# BID #709 – Ventura College STEM Program Building Improvements

## **ADDENDUM 001, dated 05/15/2025**

**DRAWING** changes and clarifications noted as Addendum 01 and dated 05/15/2025:

SHEET NUMBER: C2.0

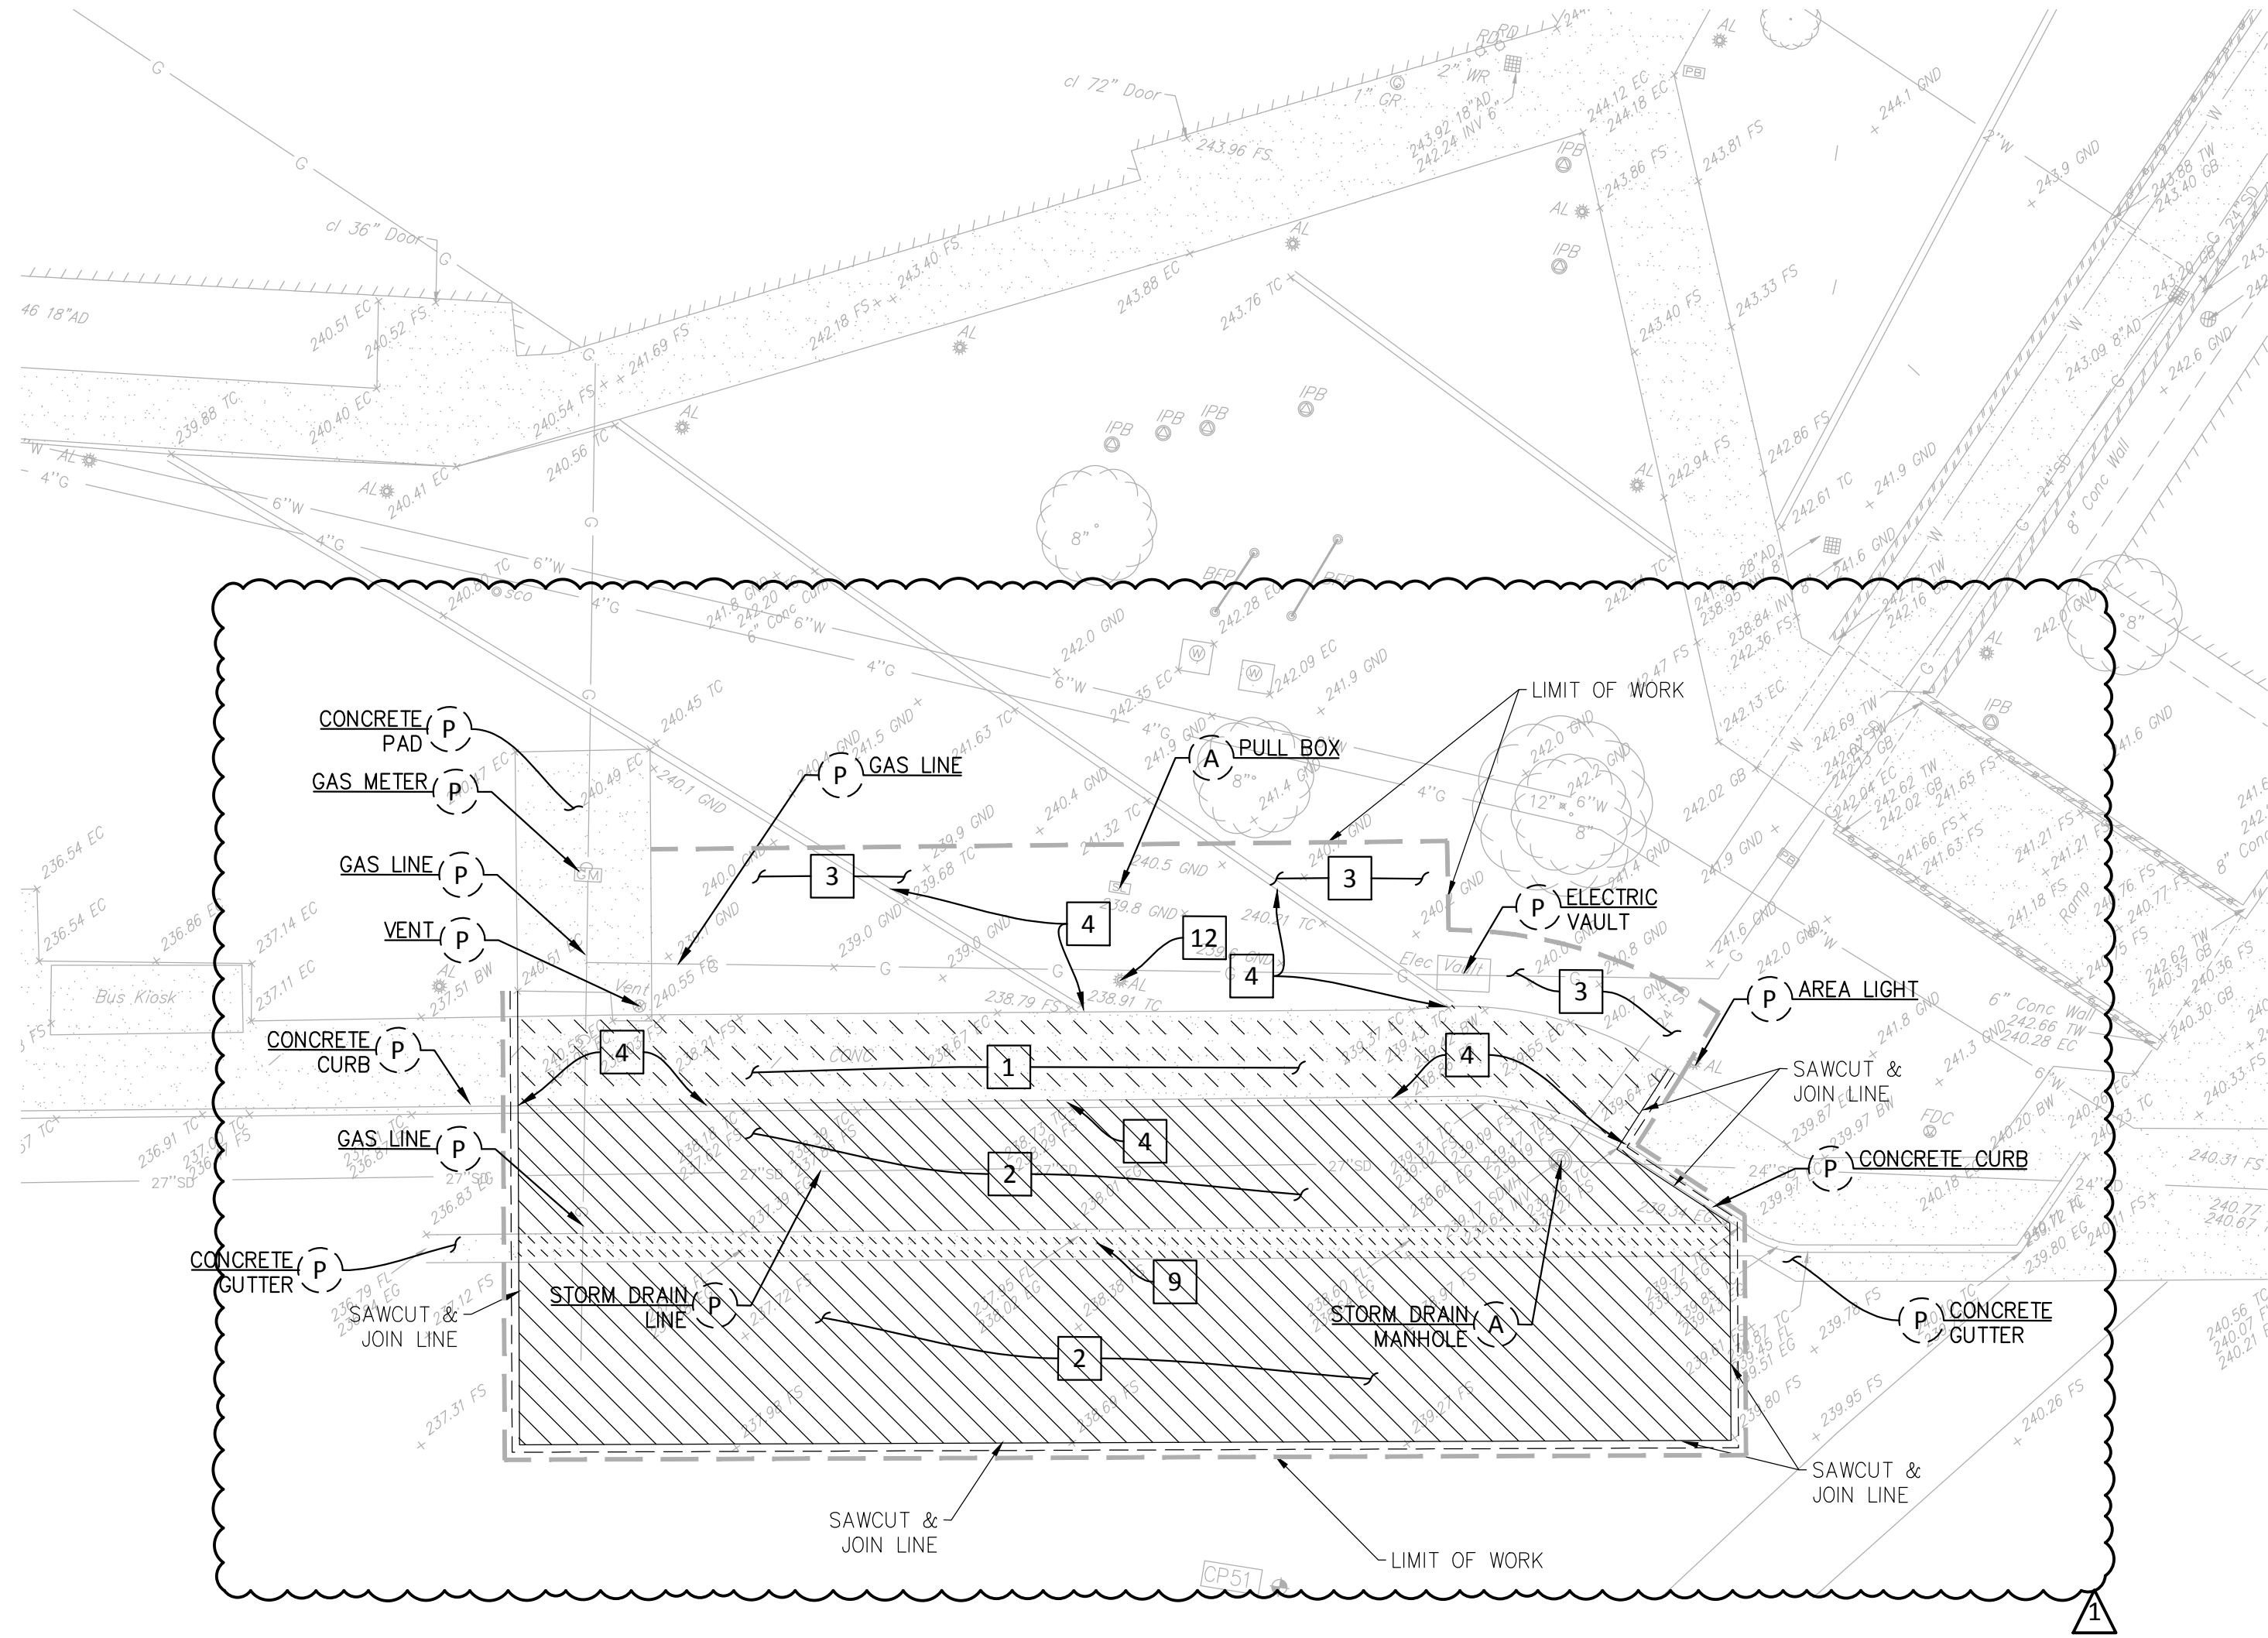
C2.0 – ADDED DEMOLITION FOR SEWER TRENCHING, ADDED EXISTING SEWER LINE WITH PROTECT IN PLACE NOTE, DEMOLITION NOTES 8, 9 AND 12

SHEET NUMBER: C2.1

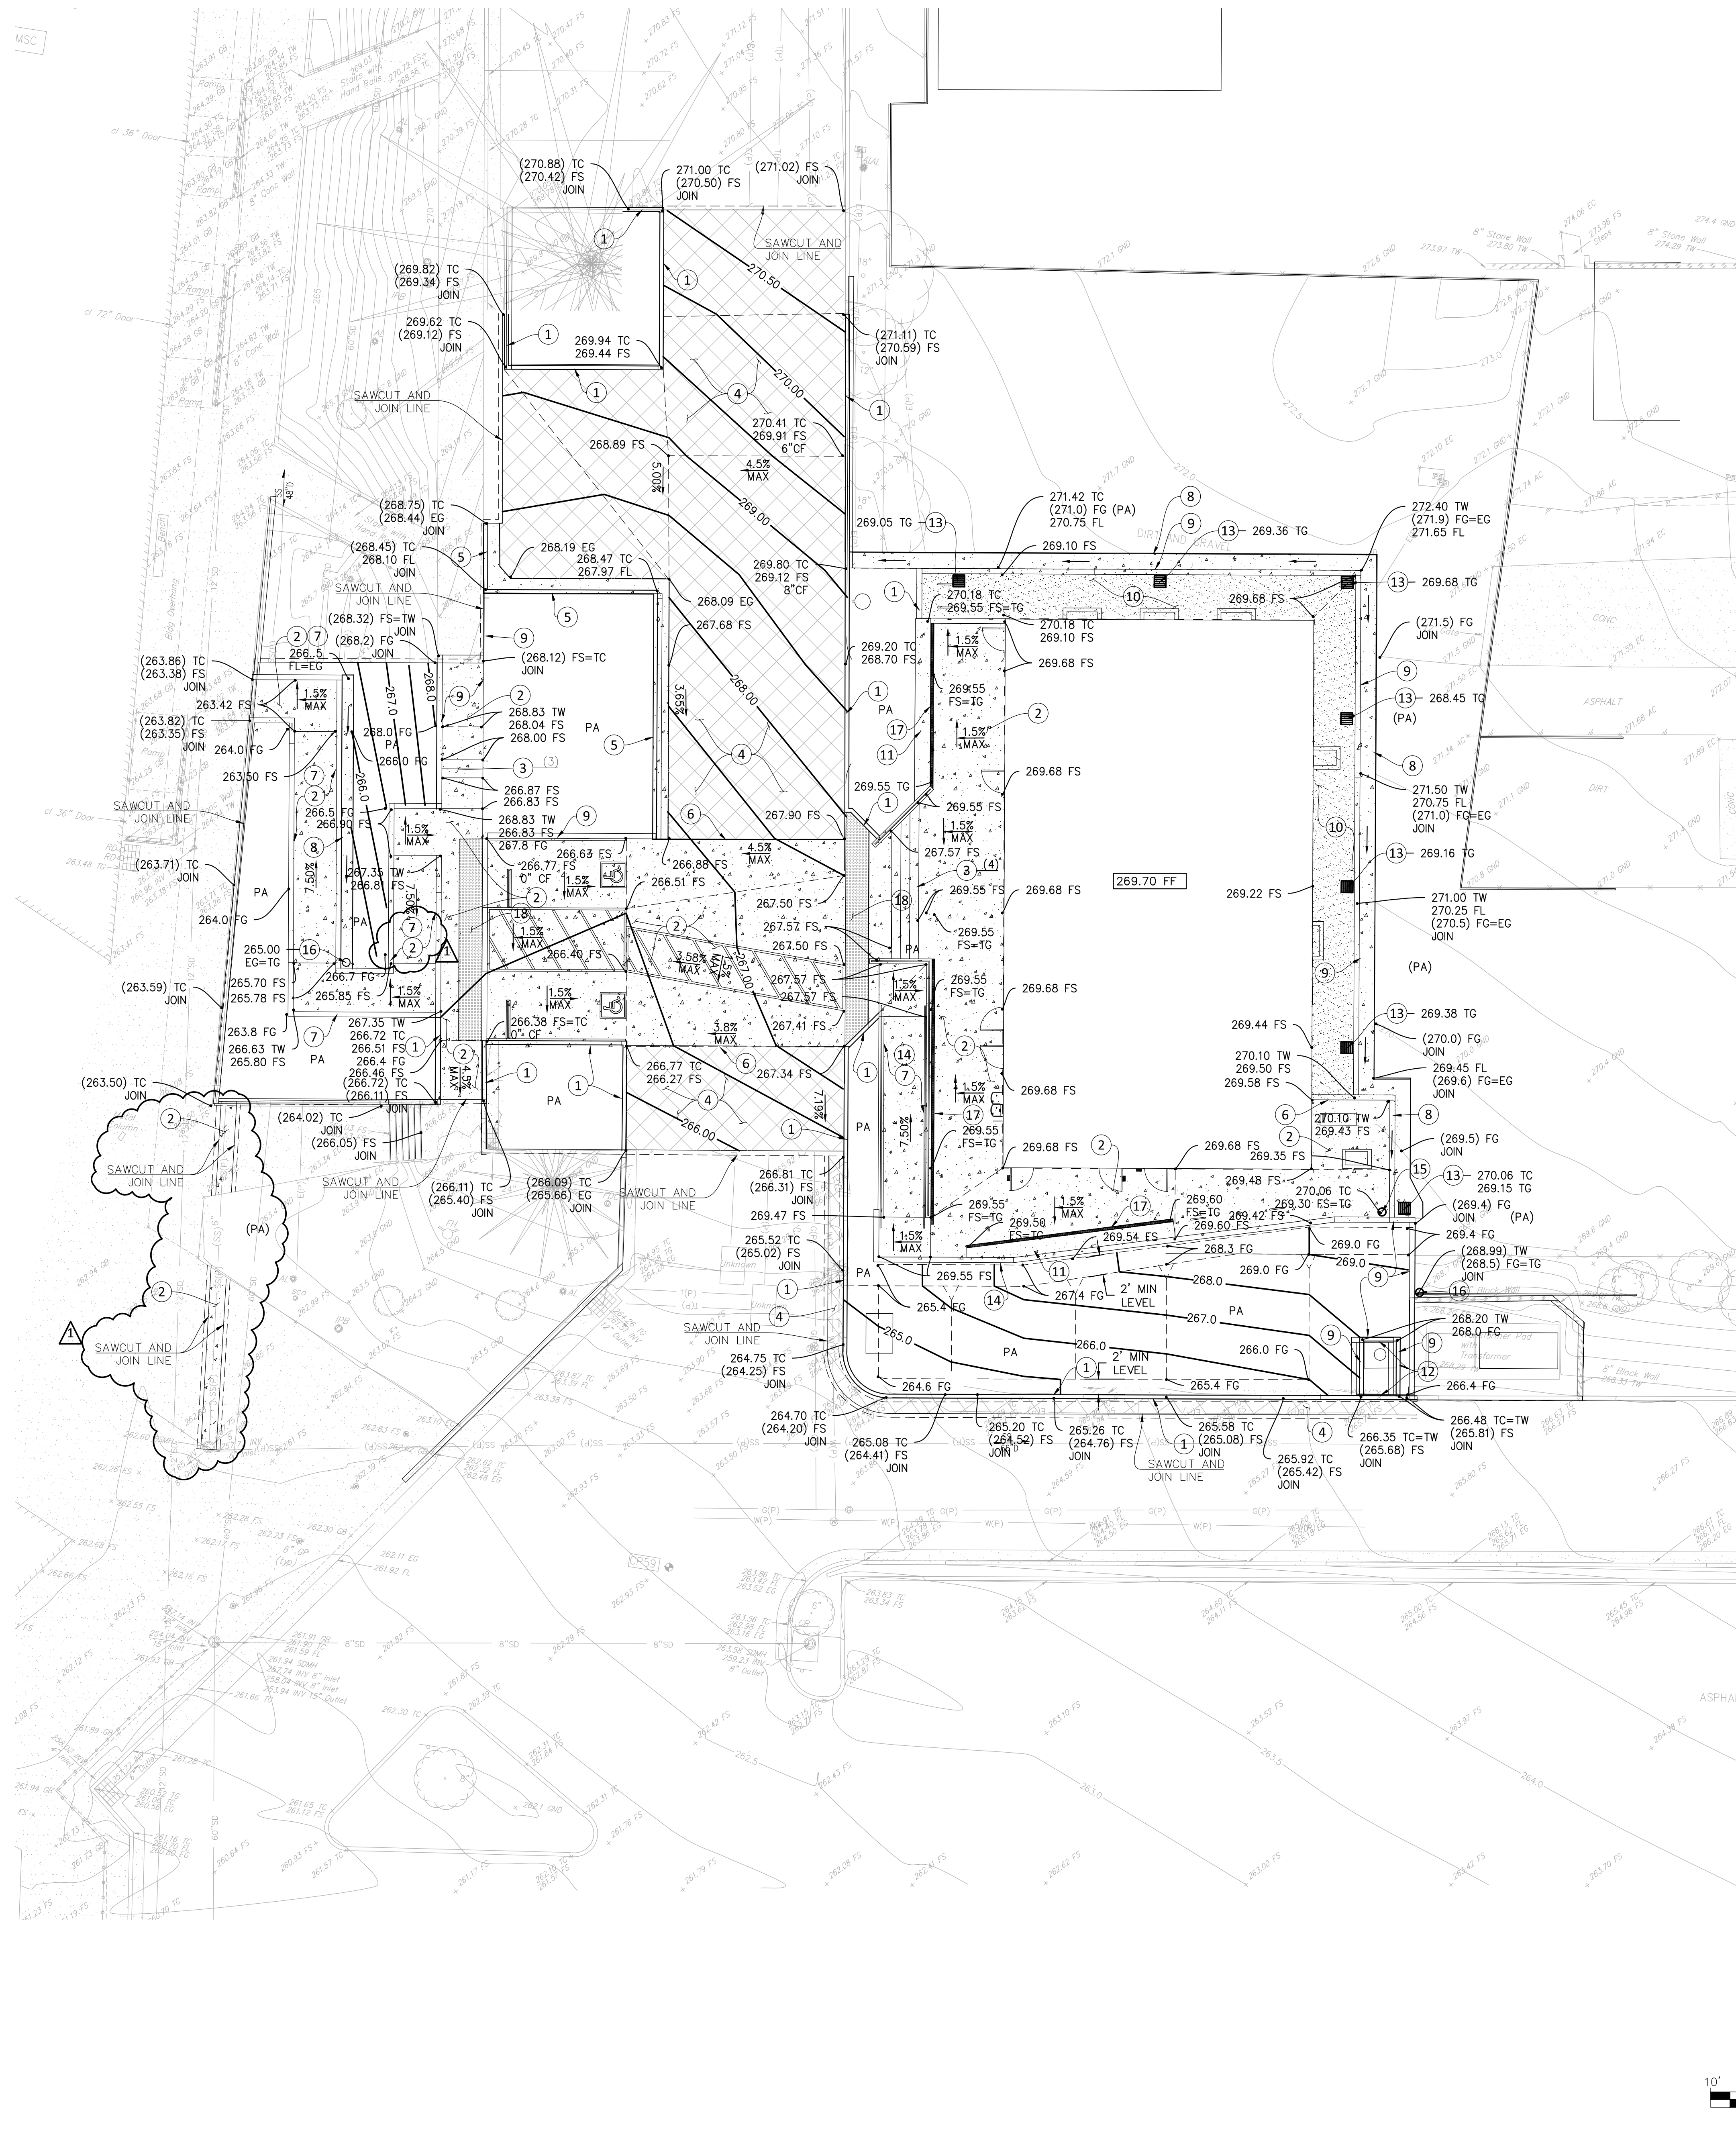
C2.1 – DEMOLITION PLAN FOR DROP-OFF AREA

SHEET NUMBER: C3.1

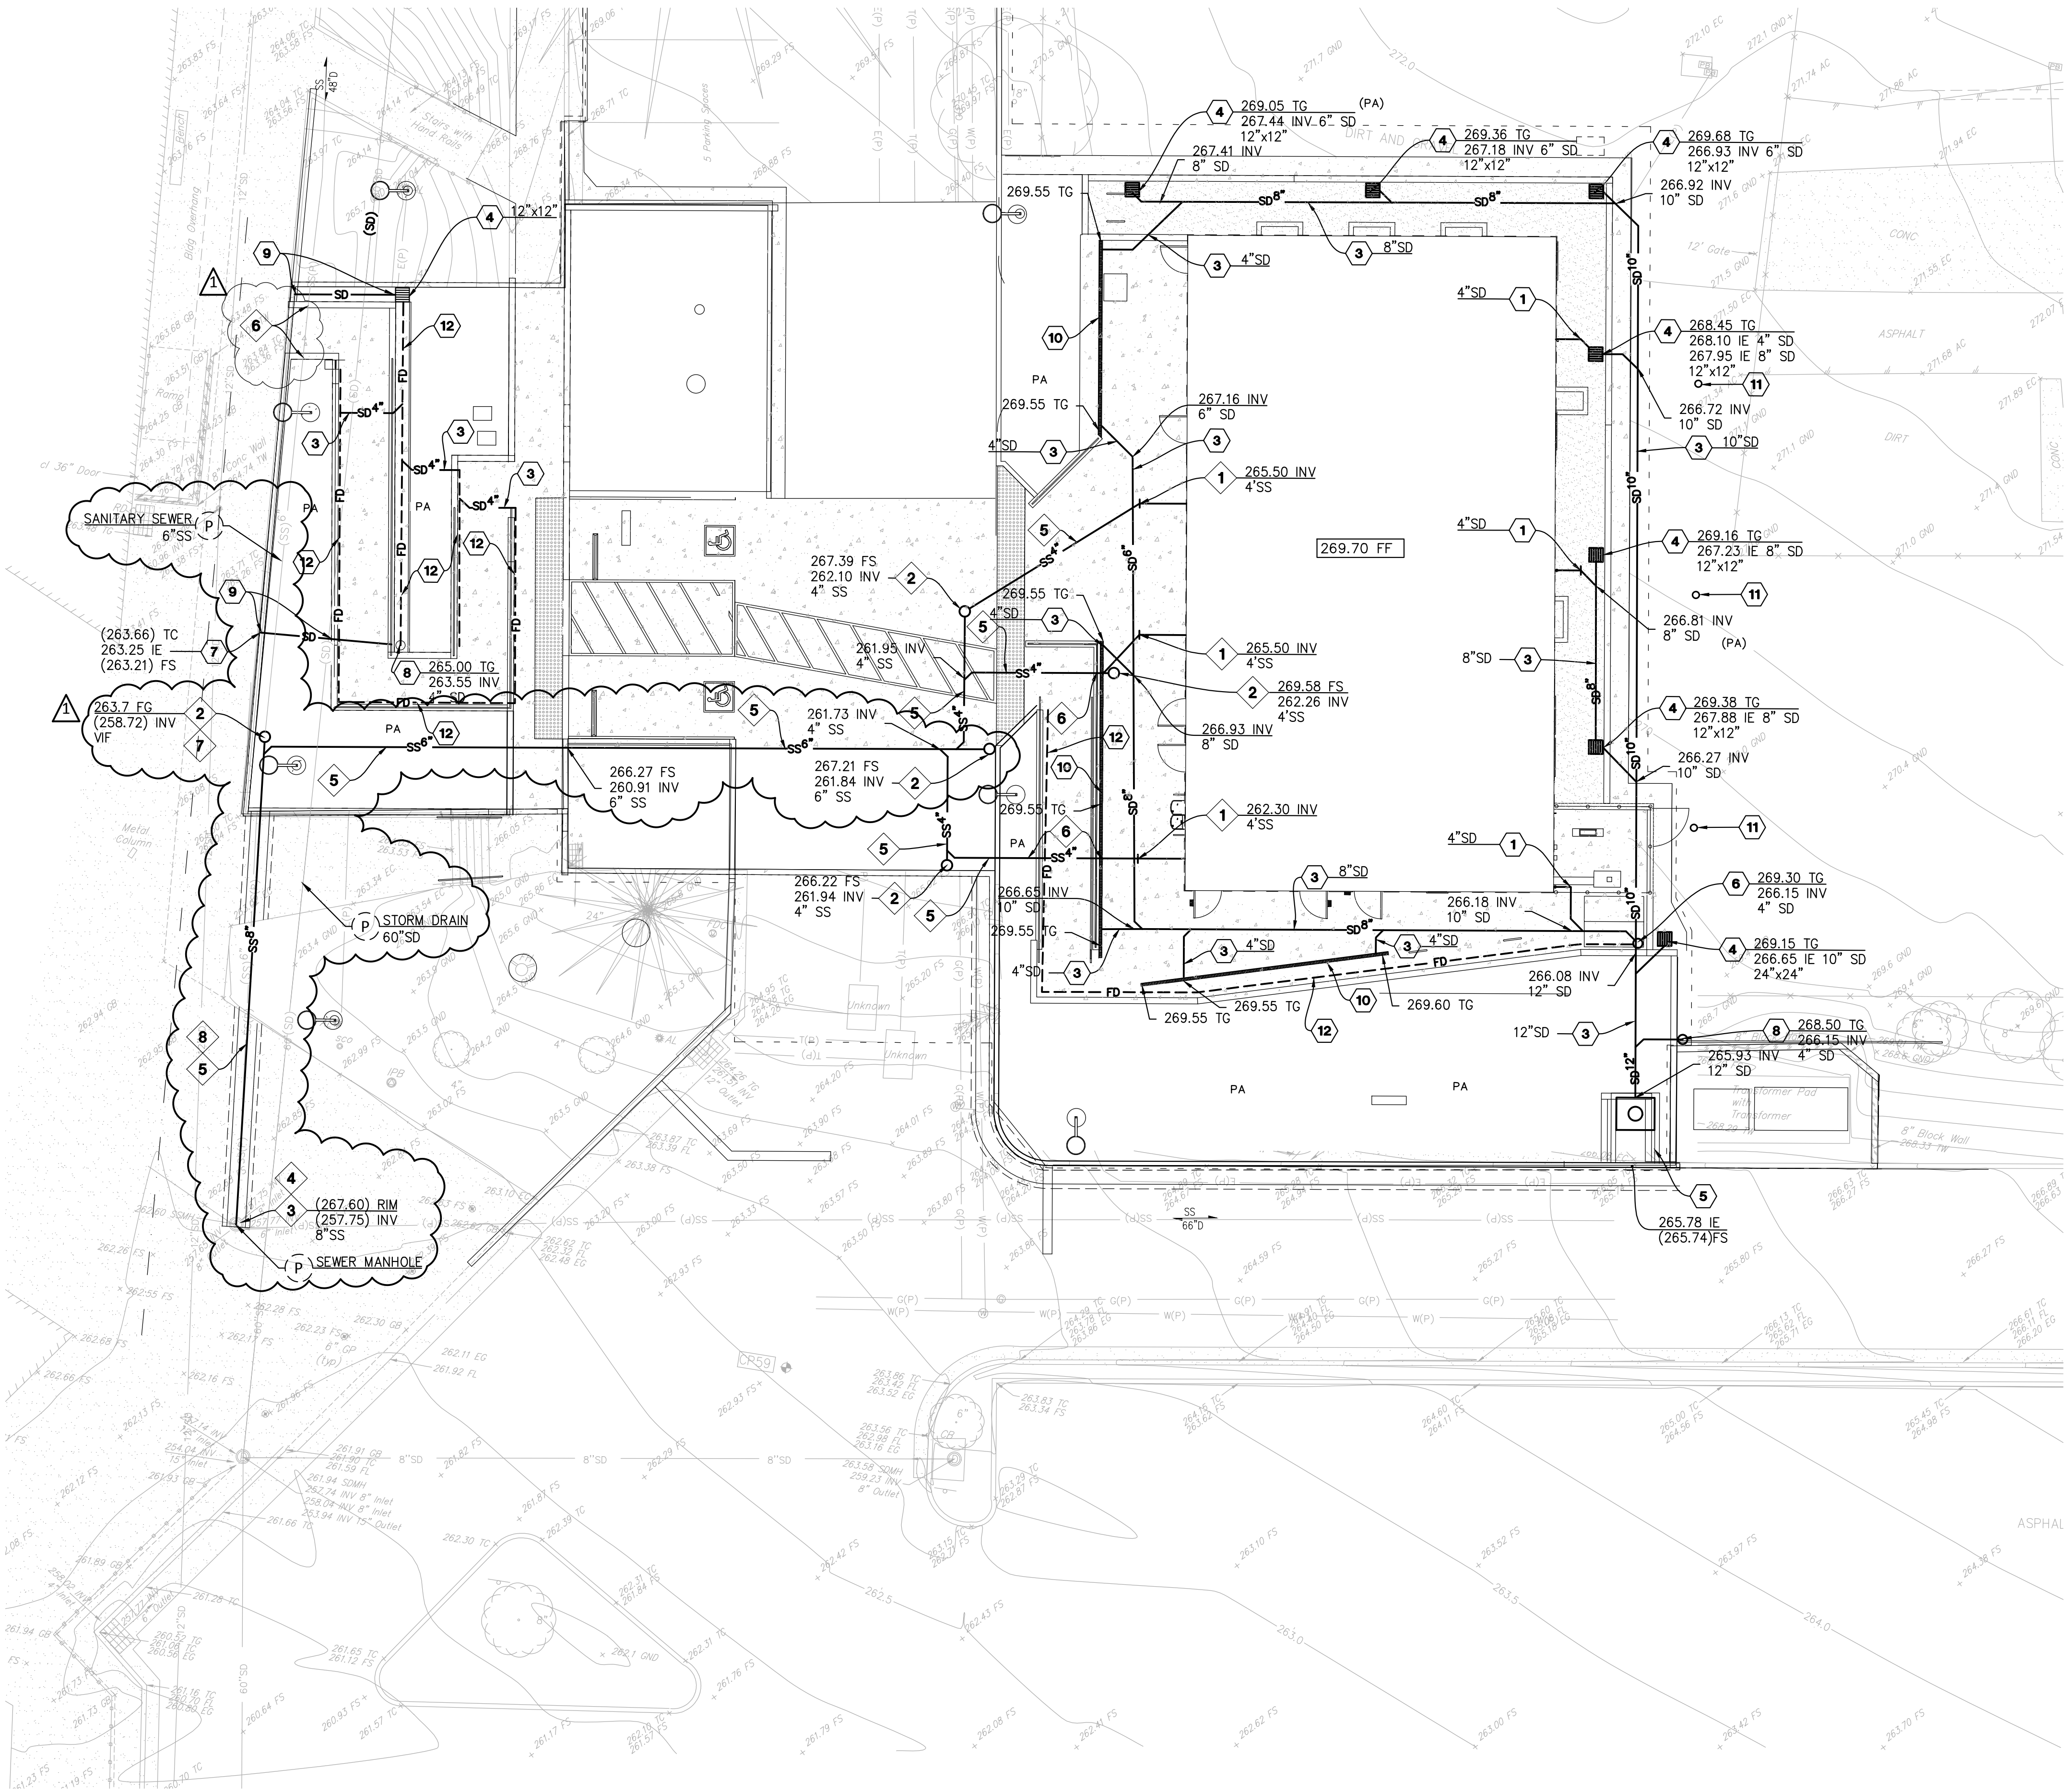
C3.1 – GRADING PLAN FOR DROP-OFF AREA
